APPLICATION

FOR PERCOLATION TESTING AND SITE EVALUATION

SUBDIVISION/PROPERTY NAME EAST SIDE OF MARYLAND ROUTE 32 OPPOSITE BURNTHOODS ROAD LOT NO. 4

From: Oswald, Hank
Sent: Wednesday, August 28, 2019 1:44 PM
To: Dave Harward, III
Subject: RE: Site Plan_Belvedere Estates_Lot 4

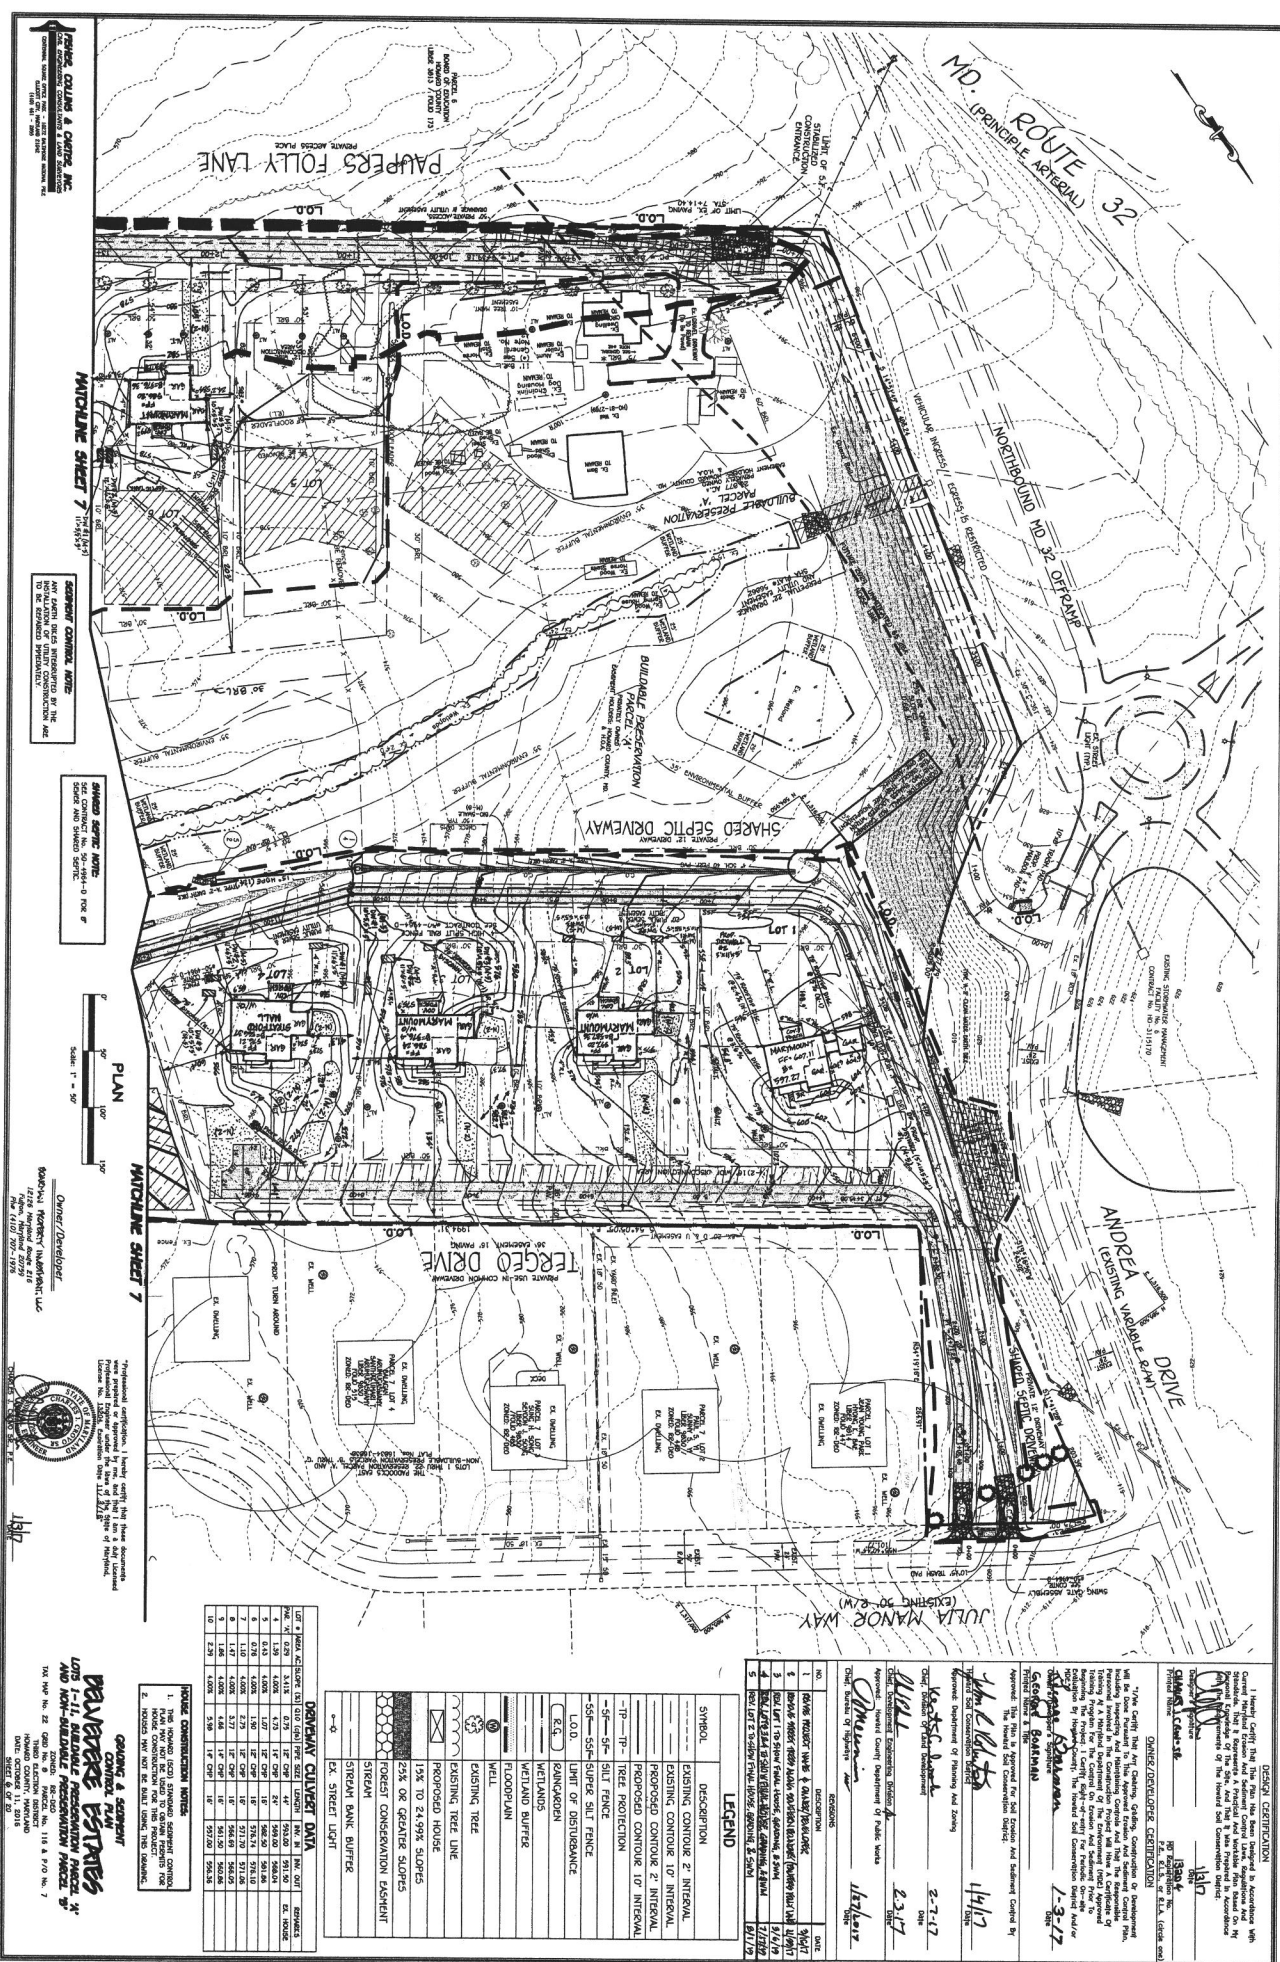
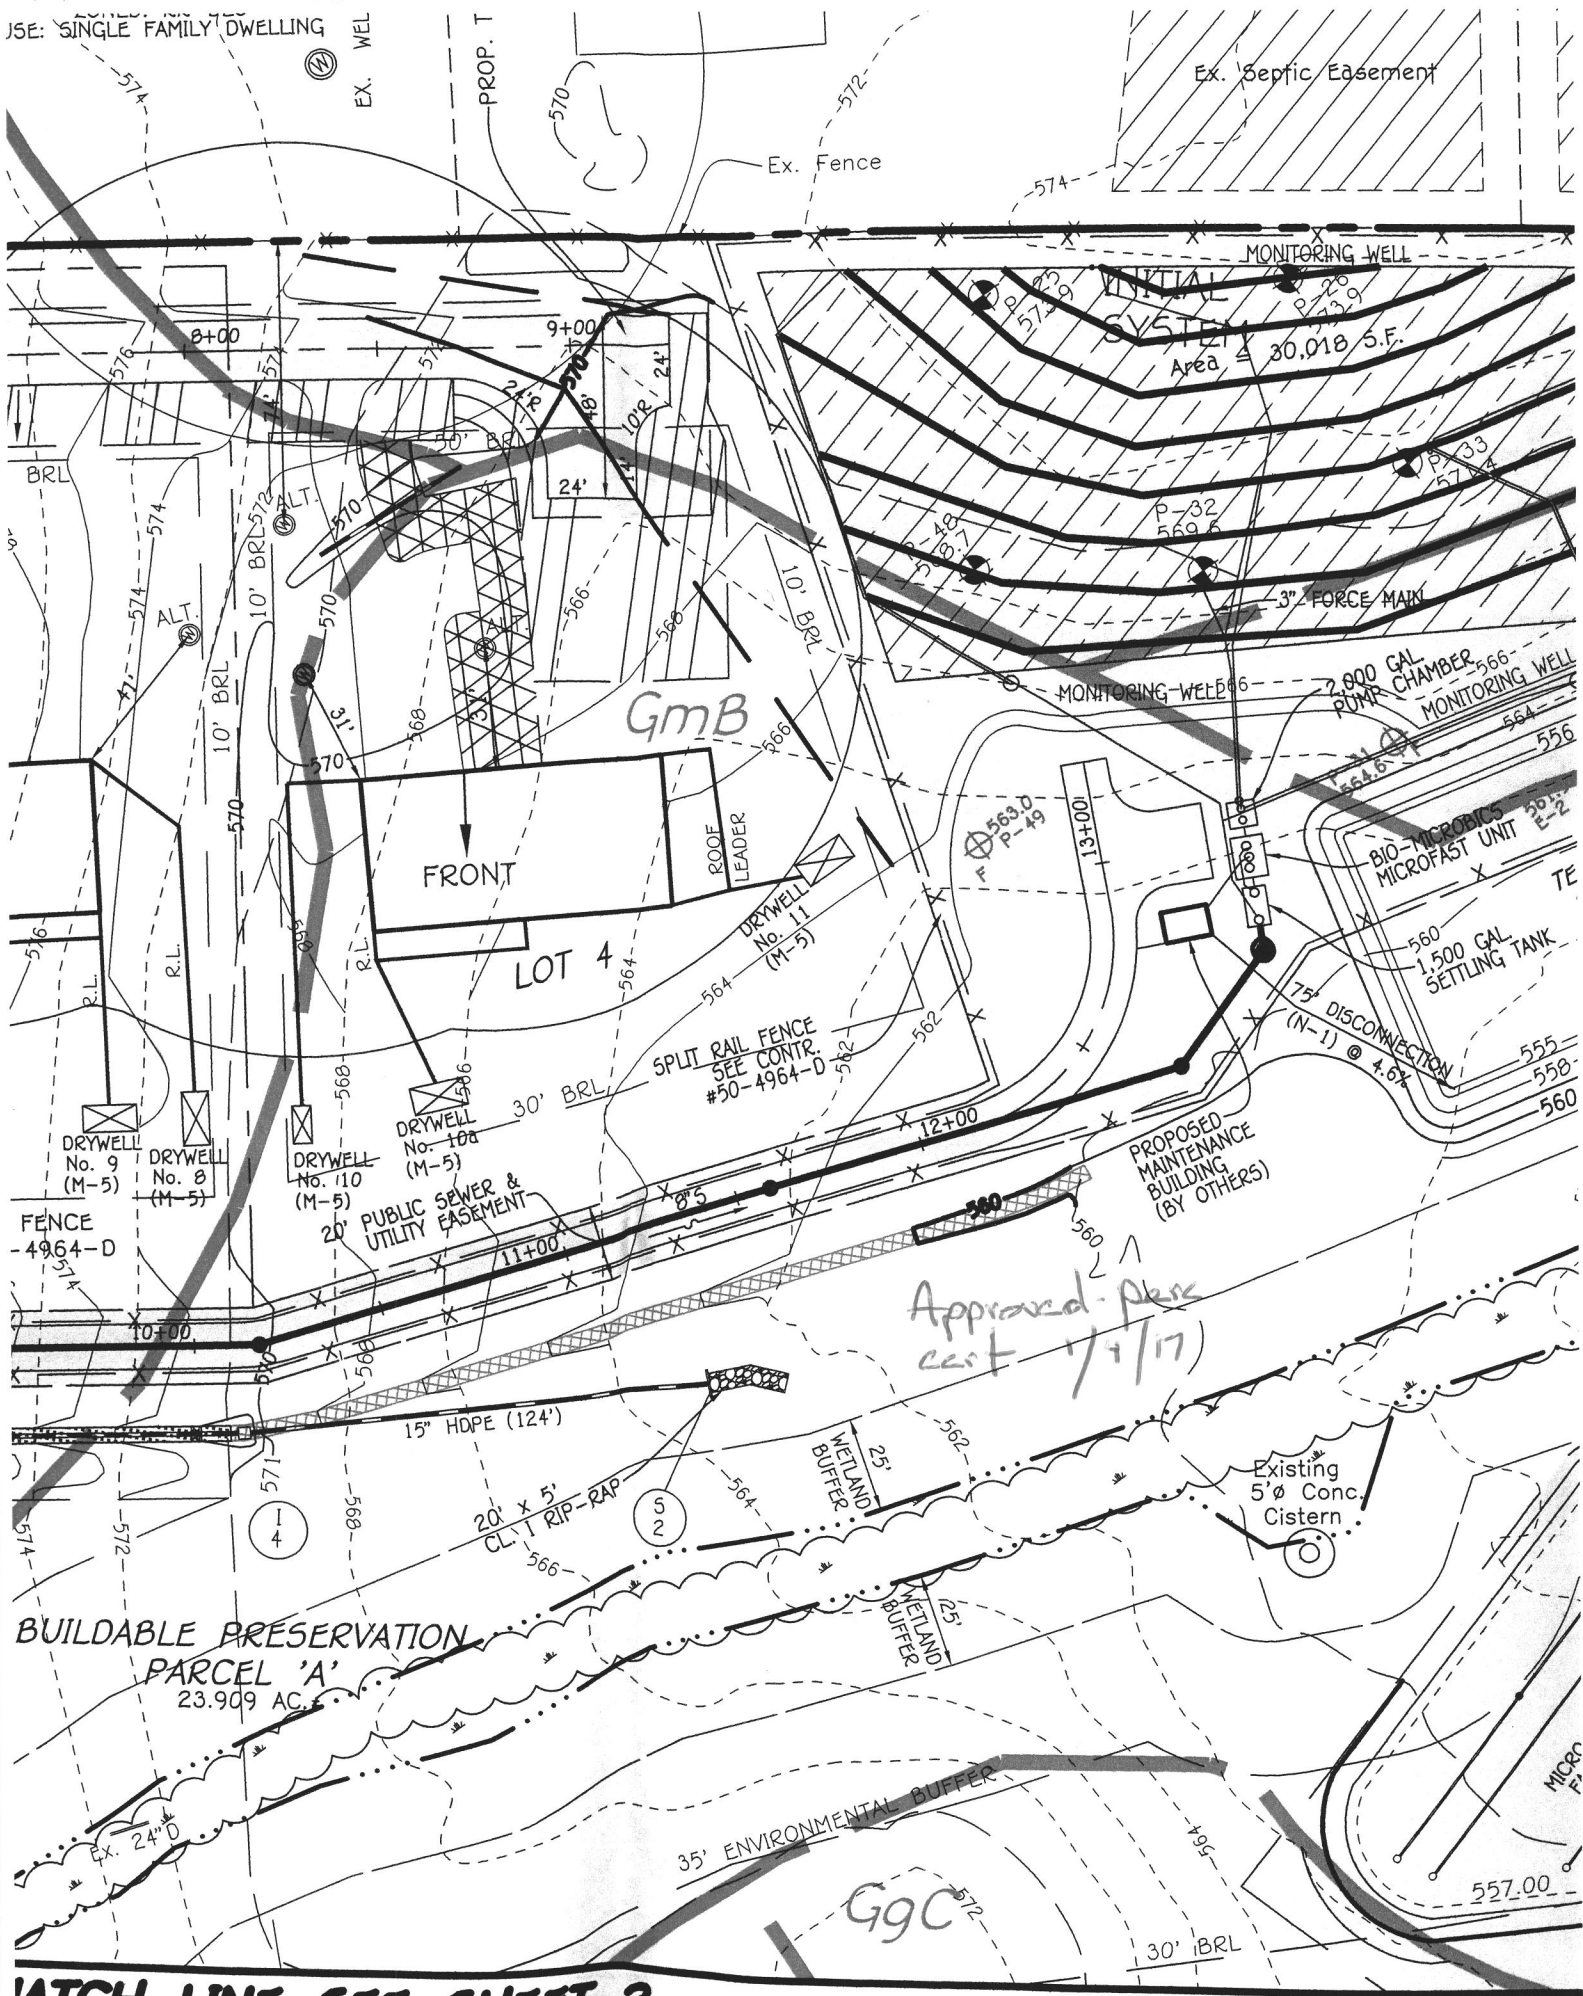
The BP site plan shows what looks to be bioretention pond (if lined) within 50 feet of the well. In addition, the point of discharge also need to be 50 feet from the alternative well site. Lastly, it doesn't show the SHC from house to sewer line.

I spoke to our Deputy Director, Mike Davis. He said the discharge end of the pipe beneath the driveway needs to be 50 feet from the alternate well site.
